## TECHNICAL SERVICE BULLETIN

### Oil Pan Leaking - Built On Or Before 15-Aug-2019

**23-2075**08 March  
2023

This bulletin supersedes 19-2387.

Figure 1

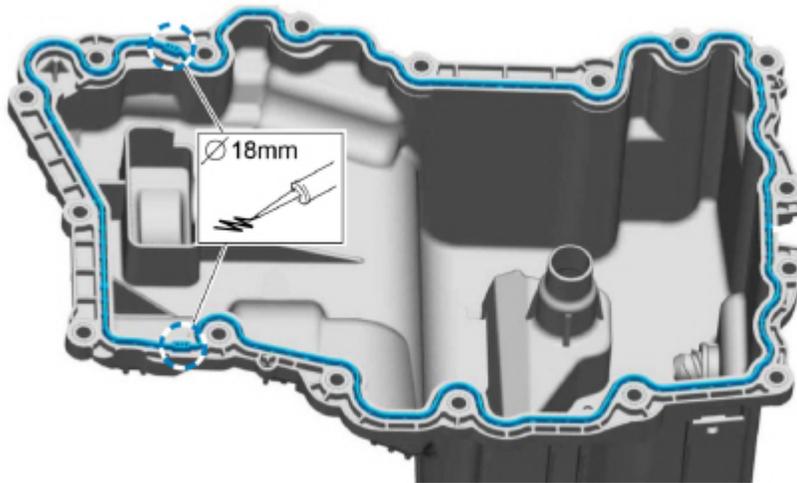
1. Remove and discard the oil pan and oil pump seal. Refer to Workshop Manual (WSM), Section 303-01.
2. Clean and prepare the engine sealing surface. Refer to WSM, Section 303-00.
3. Install the new oil pump seal.
4. Apply a 18 mm (0.708 in) bead of Motorcraft® High Performance Engine RTV Silicone to engine the front cover-to-cylinder block joint areas on the oil pan. (Figure 1)

**NOTE: The new oil pan does not require the use of Motorcraft® High Performance Engine RTV Silicone in any other location.**
